ROAD & PEDESTRIAN SAFETY IMPROVEMENTS ON GUILDFORD WAY AND DAVID AVE

No.	Date	By	Revisions
1	02-04-2026	BG	ADDENDUM #1 SOUTH CORNER POLE AND JB SHIFT
	05-03-2026	BG	ISSUED FOR TENDER
	21-01-2026	BG	DETAILED SUBMISSION
	28-04-2025	BP	PRELIMINARY SUBMISSION

Project: **GUILDFORD WAY FALCON DRIVE TRAFFIC SIGNAL MODIFICATIONS**
Description: _____
File: 8358-24
COQ. ASBULT No. **EXXXX**

Project: **GUILDFORD WAY LANSDOWNE DRIVE TRAFFIC SIGNAL MODIFICATIONS**
Description:
File: 8358-24

Project: **GUILDFORD WAY FALCON DRIVE**
 Description: **TRAFFIC SIGNAL MODIFICATIONS**
 File: 8358-24

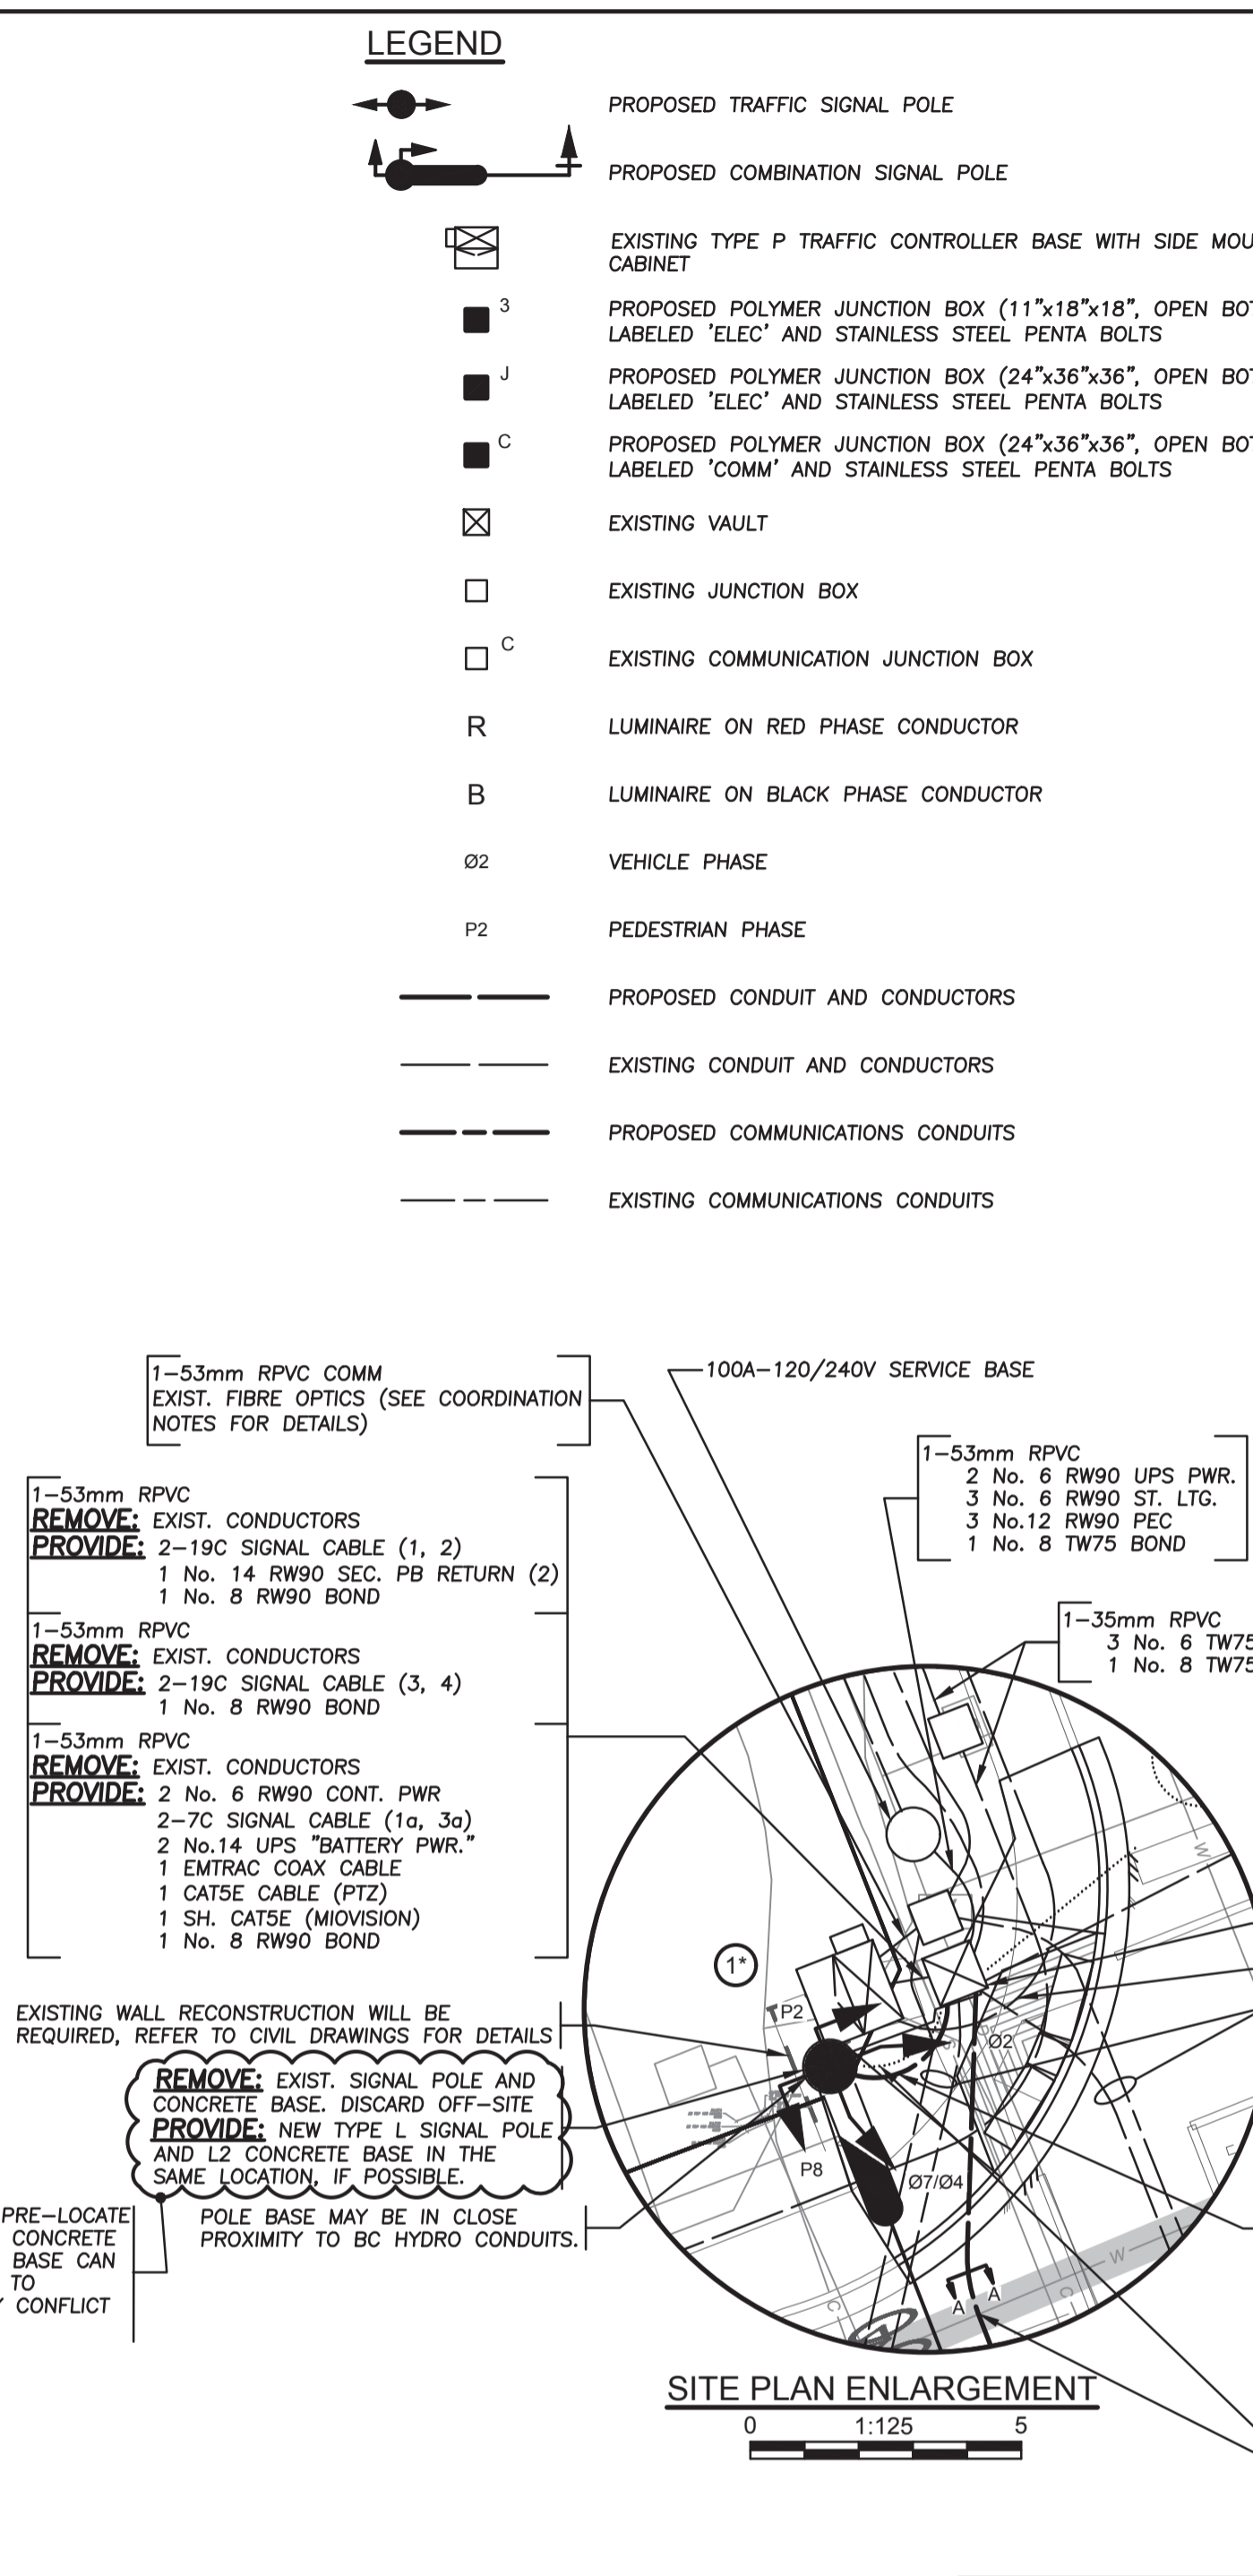
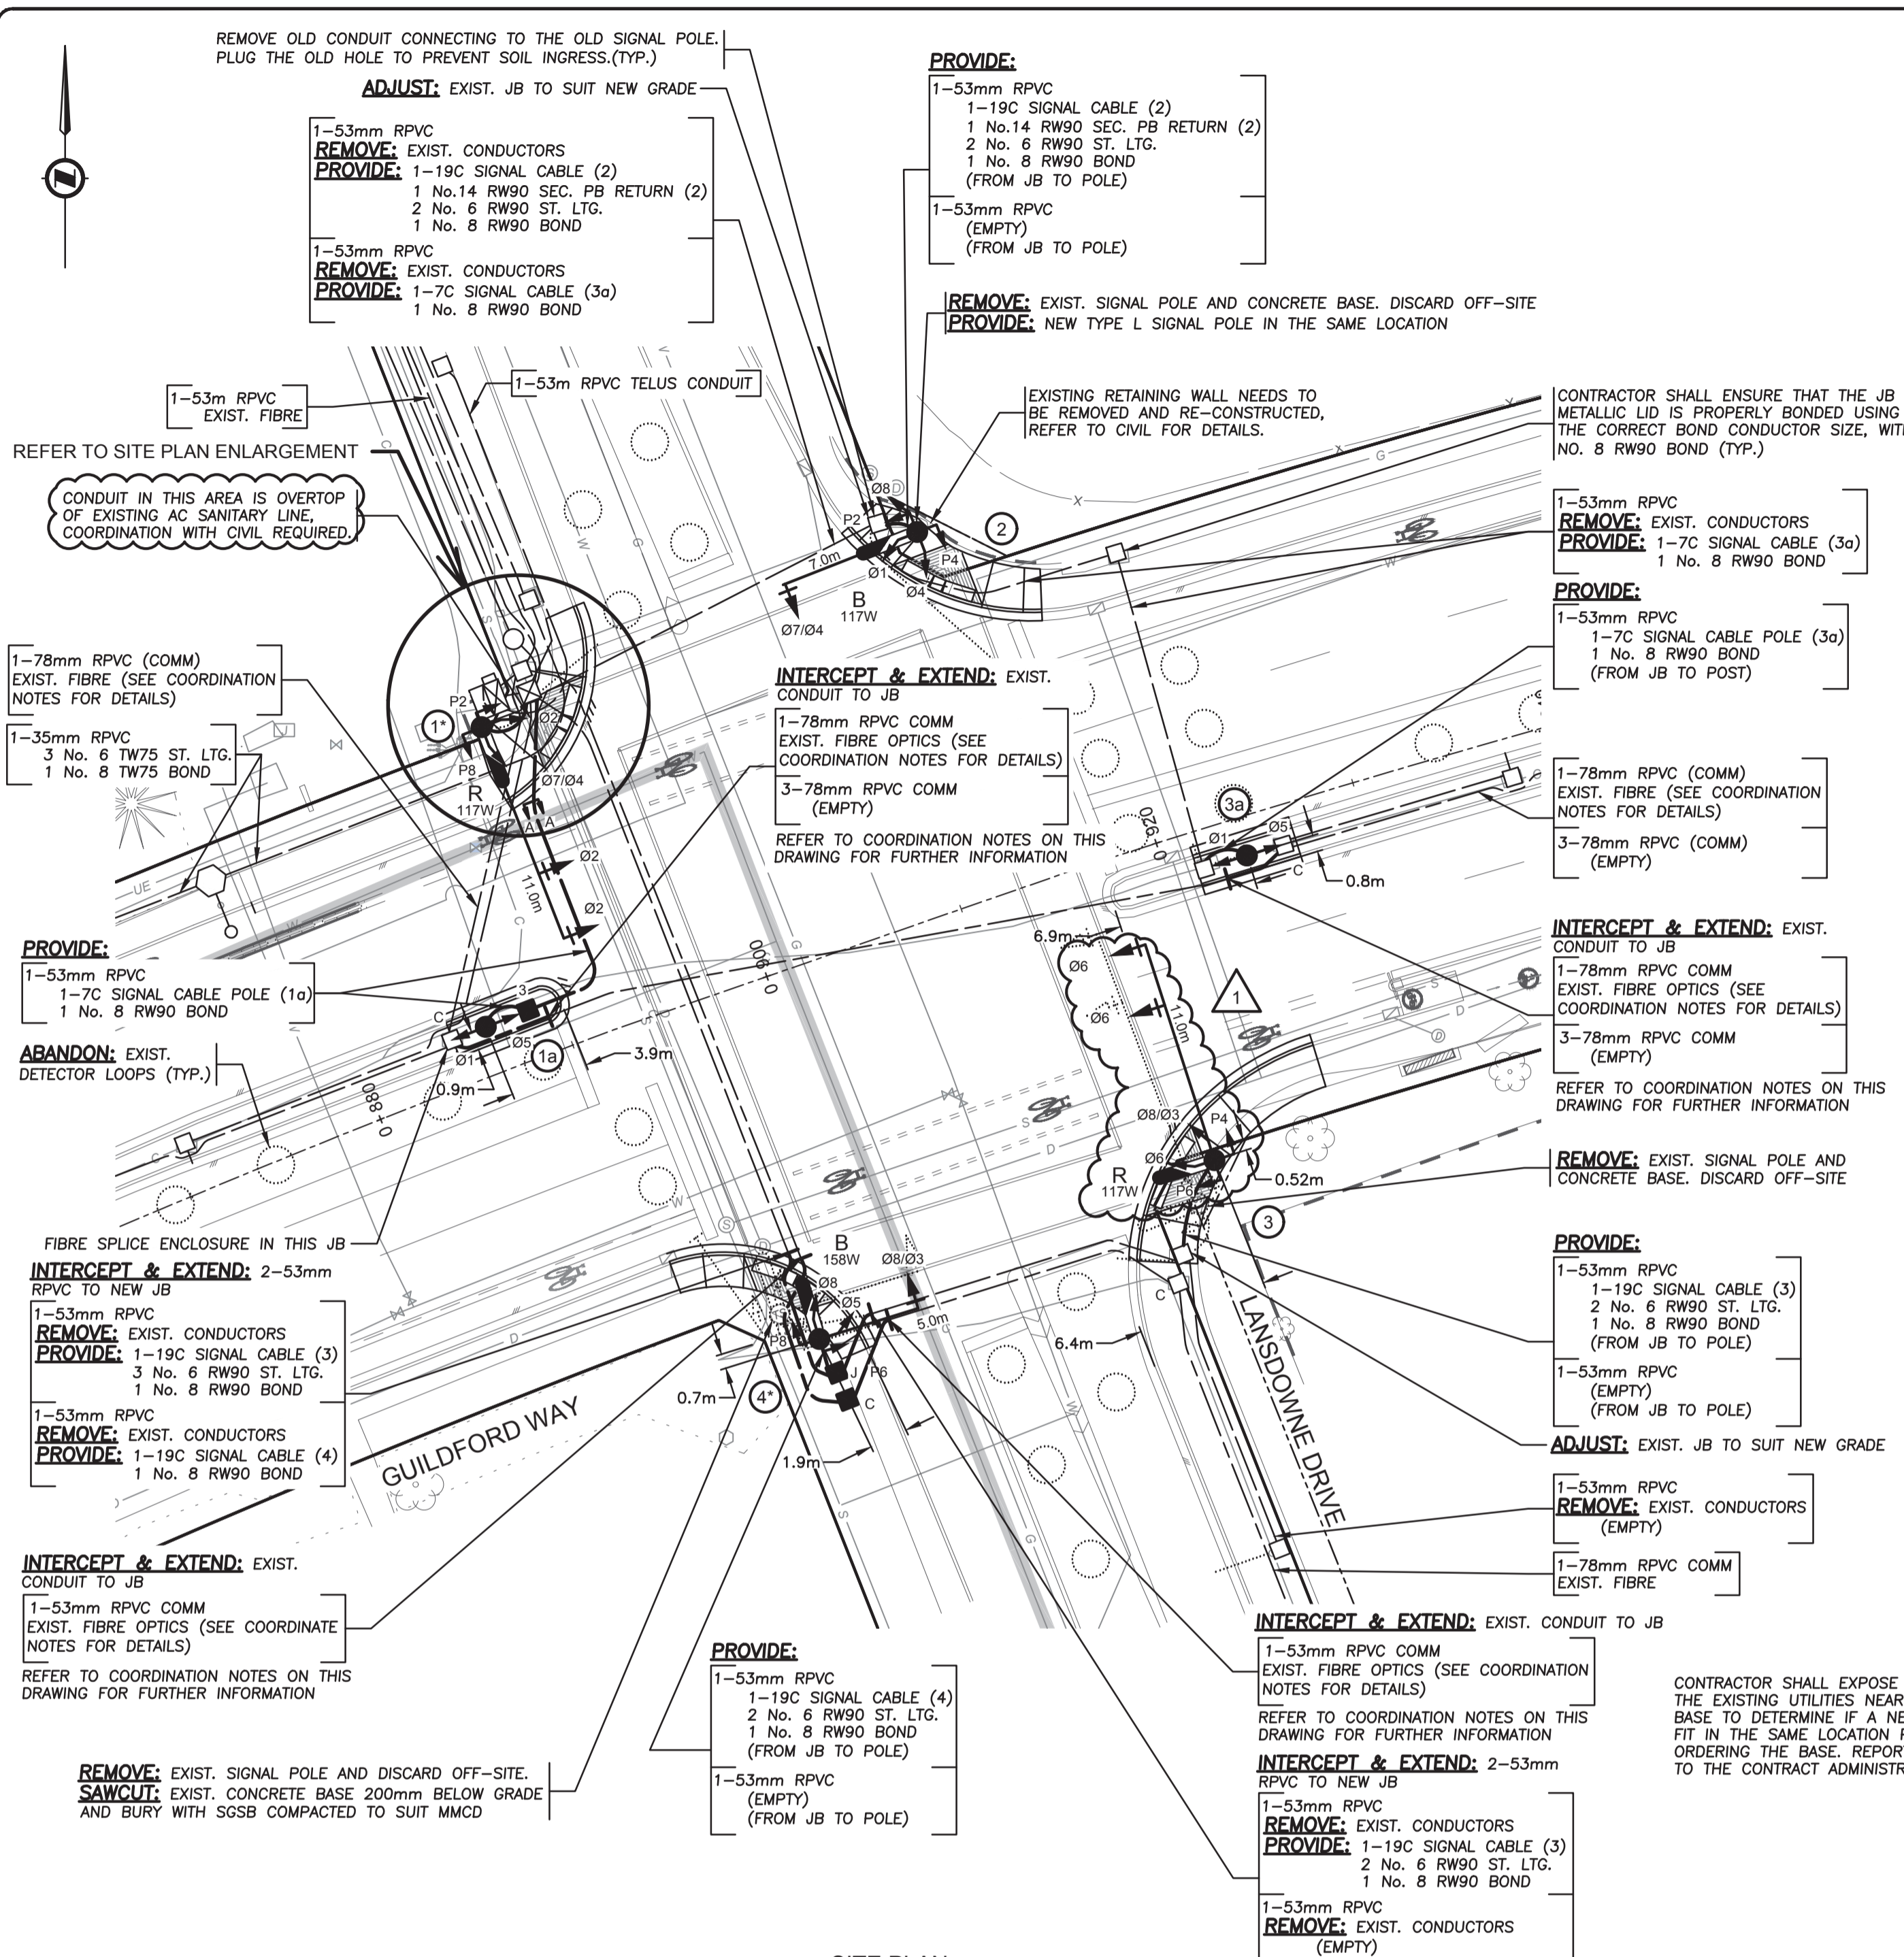
No.	Date	By	Revisions
1	02-04-2026	BG	ADDENDUM #1 SOUTH CORNER POLE AND JB SHIFT
	05-03-2026	BG	ISSUED FOR TENDER
	21-01-2026	BG	DETAILED SUBMISSION

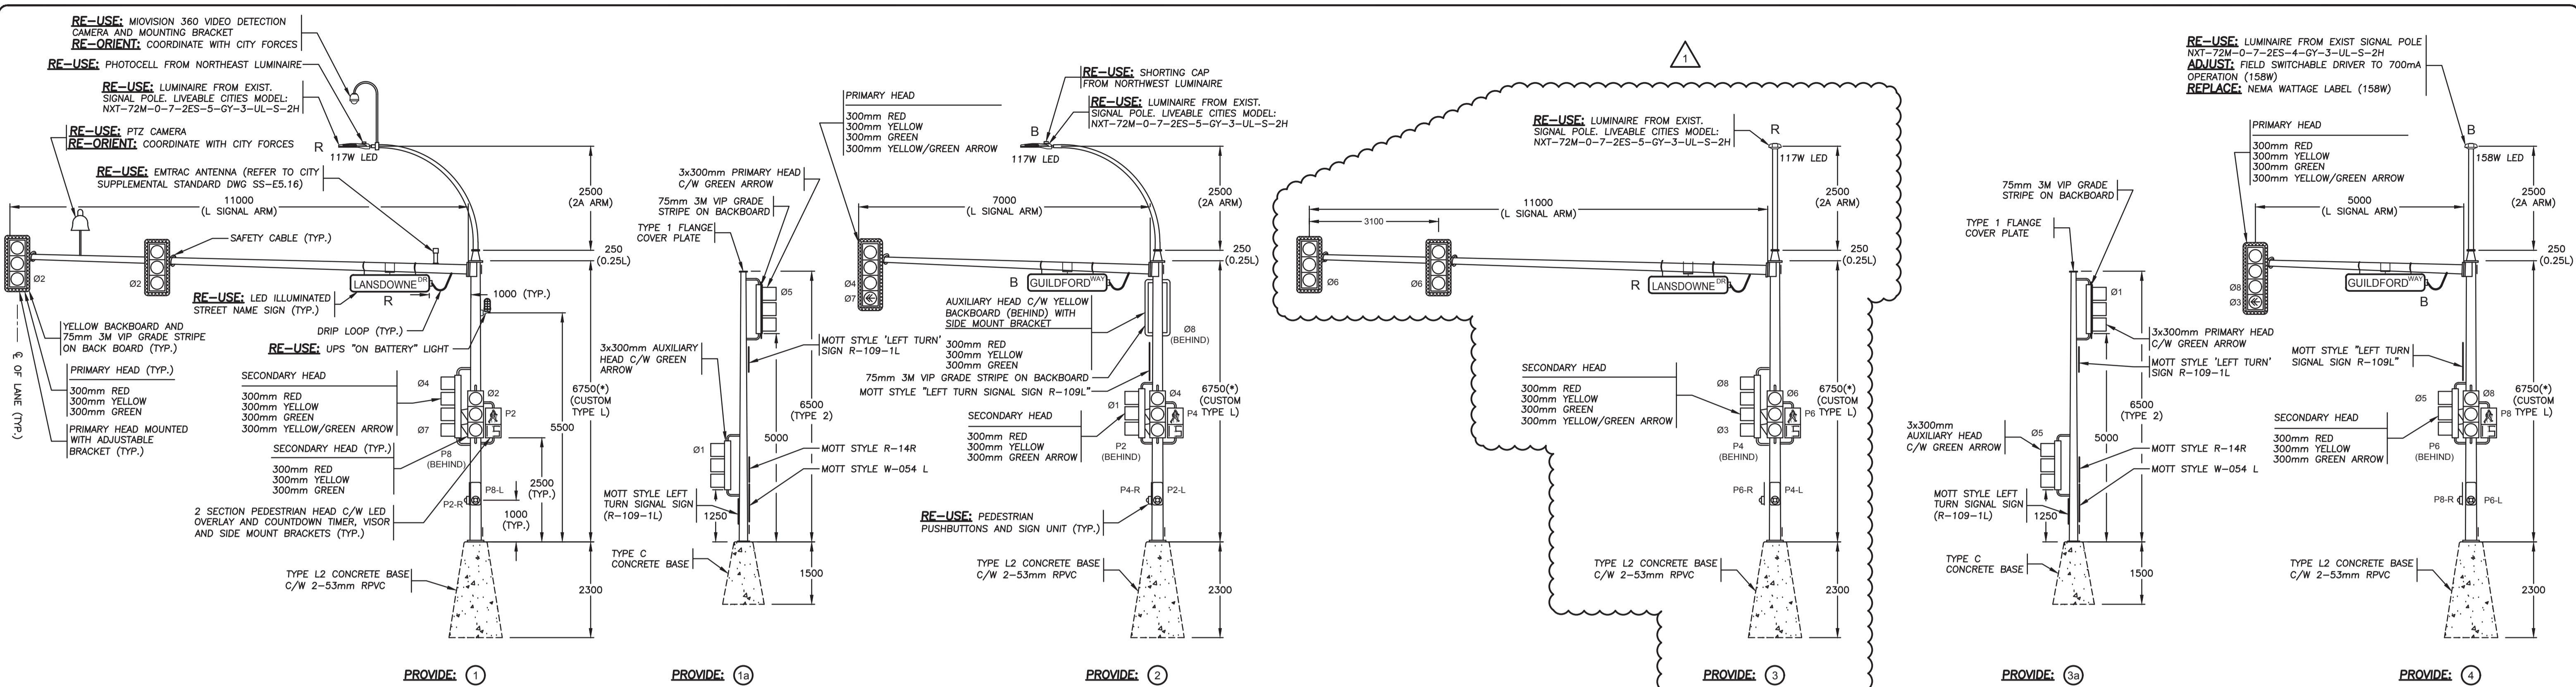
No.	Date	By	Revisions
1	02-04-2026	BG	ADDENDUM #1 - POLE 2 LOCATION AND POLE TYPE CHANGE
	05-03-2026	BG	ISSUED FOR TENDER
	21-01-2026	BG	DETAILED SUBMISSION
	28-04-2025	BP	PRELIMINARY SUBMISSION
